Memorandum

RE: **P.Z. 09-2019 18301 & 18357 Chesterfield Airport Rd. (Nasrallah Global RE Services)**: A request for a zoning map amendment from a “M3” Planned Industrial District to a “PC” Planned Commercial District for a 15.9-acre area of land comprised of two (2) parcels at 18301 and 18357 Chesterfield Airport Road, located northwest of the intersection of Chesterfield Airport Road and Spirit of St. Louis Boulevard. (17V430035 and 17W620301).

Planning Commission Issues and Vote Report

Petition: **P.Z. 09-2019 18301 & 18357 Chesterfield Airport Rd. (Nasrallah Global RE Services):**
A request for a zoning map amendment from a “M3” Planned Industrial District to a “PC” Planned Commercial District for a 15.9-acre area of land comprised of two (2) parcels at 18301 and 18357 Chesterfield Airport Road, located northwest of the intersection of Chesterfield Airport Road and Spirit of St. Louis Boulevard. (17V430035 and 17W620301).

PRELIMINARY PLAN

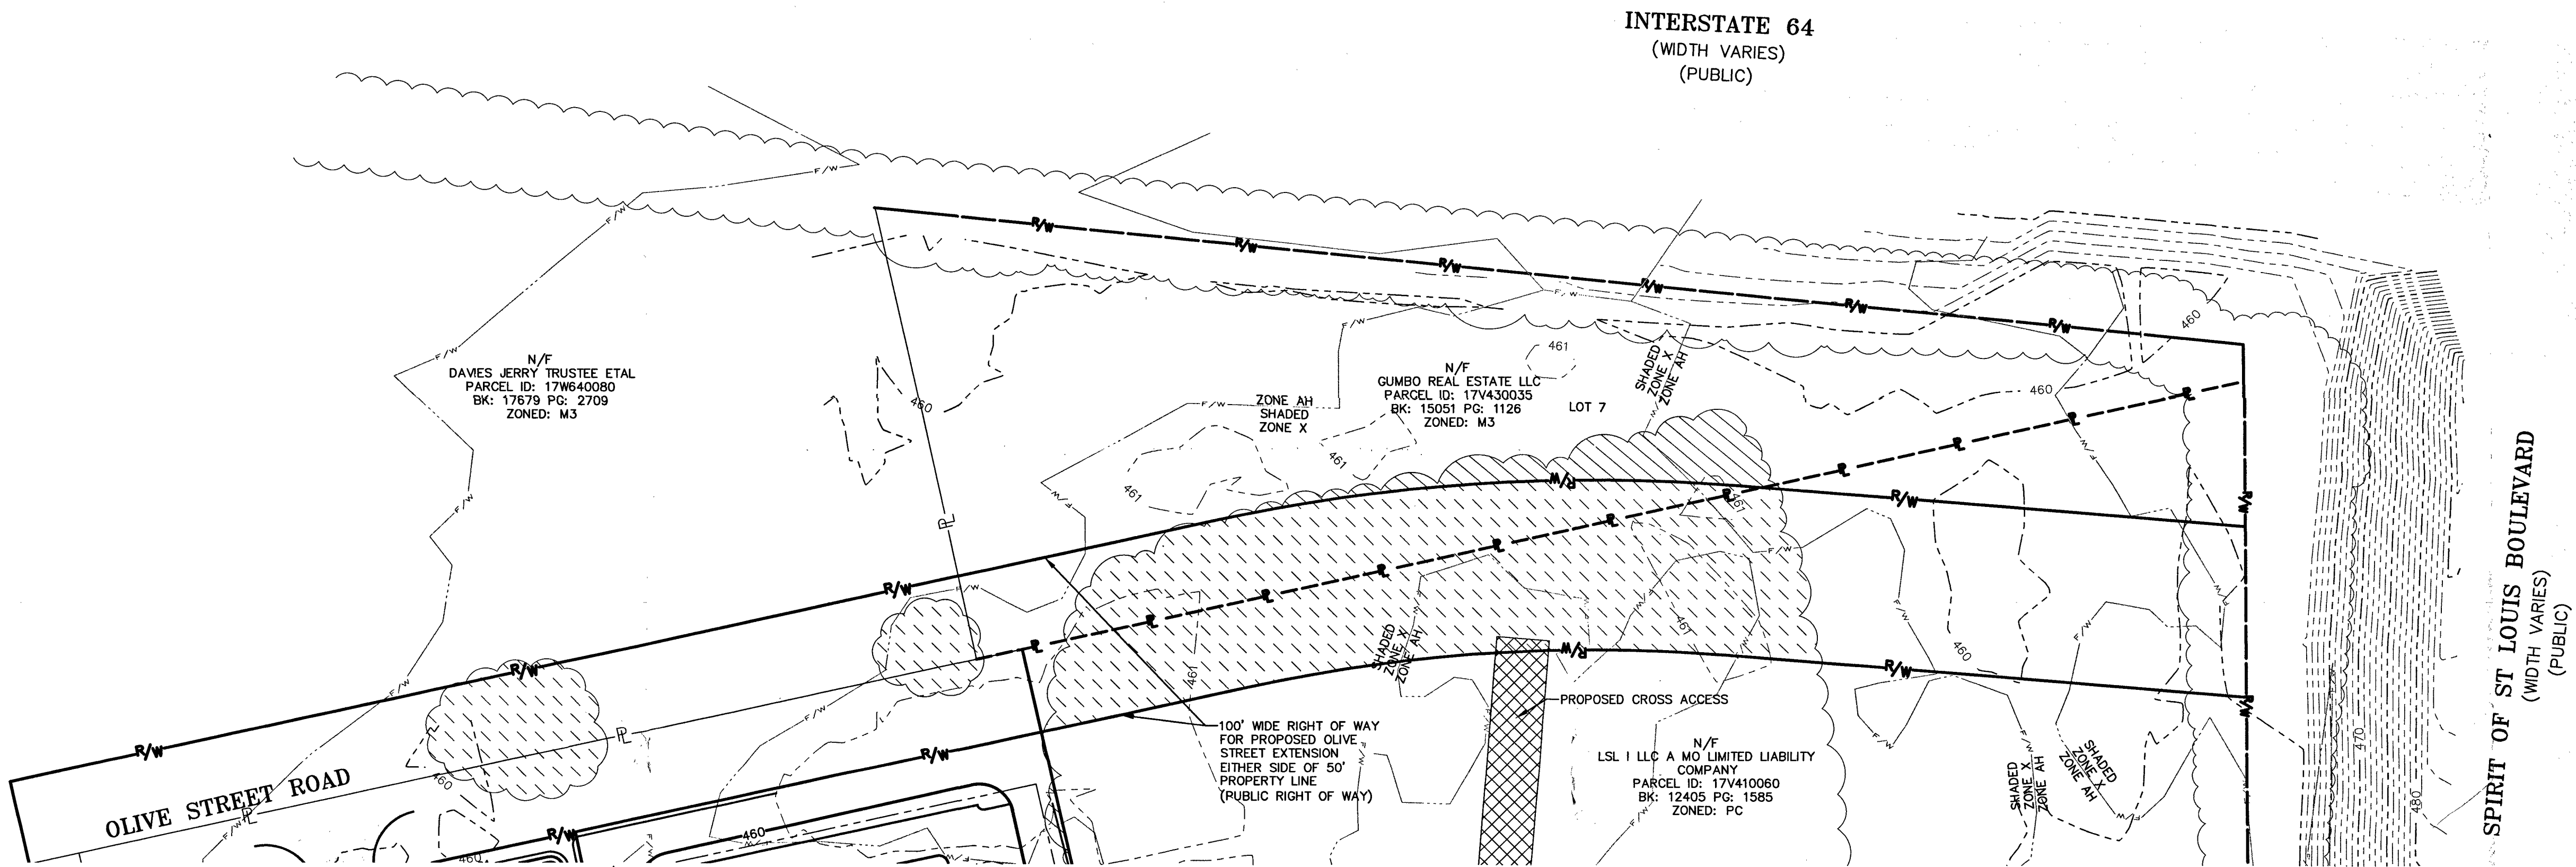
1. **Access:** *Concern was raised over the amount of proposed access connections into the development, specifically onto arterial roadways (Chesterfield Airport Road and Olive Street Road Extension). Furthermore, clarification was needed of how the cross-access easement within this development connects to the private road in the development to the west, as a property not part of this petition lies between them.*

2. ***Historic Structure:*** *Questions were raised regarding the future of the historic brick barn found on the property.*

3. ***Parking Along Chesterfield Airport Road:*** *Concern was raised by members of the Planning Commission regarding limiting the parking along Chesterfield Airport Road, as stipulated in the Chesterfield Valley Design Requirements.*

Applicant's Response: After receipt of the Issues Letter, the applicant has stated that both arterial road access points are needed for this development. Even with the portion of the Olive Street Road extension shown on the Preliminary Plan, it would not grant access to any currently constructed roadway. As of now, the only the portion of the road that has been constructed is located on the Chesterfield Ice and Sports complex development, with no other part of the road adjacent to this development planned to be constructed at this time. As such, Chesterfield Airport Road would be the only viable access point to or from the property and is currently the main arterial road that provides access for commercial and industrial properties in the western portion of Chesterfield. The access point connecting to Olive Street Road will eventually divide the traffic flow in and out of the development, alleviating congestion by utilizing two arterial access points instead of one. Both access points shall comply with the City's Access Management Standards established in the Unified Development Code.

The draft "Attachment A" attached to this report specifies that a Traffic Study shall be provided prior to the approval of any development. Specifically, this Traffic Study shall include an evaluation of safety and operations of each arterial access point's intersection. In the event that the study shows unsafe or poor operating conditions, modifications to access, including the

removal of such proposed access location(s) shall be implemented. Furthermore, it limits the development to no more than one (1) access point along either arterial road.

Regarding the cross-access to the west, the adjacent property to the west is under separate ownership and is not a part of this development. As such, the cross-access easement to the west has been provided on the Preliminary Plan to align with that of the adjacent development, based on the Site Development Concept Plan that was approved with the Valley Village Subdivision. The Attachment A dictates that cross-access to adjacent developments shall be as directed by City of Chesterfield and St. Louis County Department of Transportation.

Applicant's Response: The submitted Preliminary Plan shows the historic barn to remain. The applicant has stated that the barn is an asset to the property and thus intends to keep it in place. While there have been several ideas and suggestions as to what the historic structure may become, its uses may be any of those listed under the Permitted Uses section of the Attachment A. Staff has also added language for these provisions under the "Miscellaneous" section of the Attachment A.

Applicant's Response: The applicant has responded to this concern by stating that the parking areas shown on this plan are only to demonstrate the proposed amount of parking needed, not necessarily their specific layout and locations. Specific requirements for Chesterfield Valley Design Standards shall be followed for each individual lot once Site Development Plans are submitted. Parking and loading spaces for this development shall be as required in the City of Chesterfield Code. Staff has added this language in the Attachment A as well.
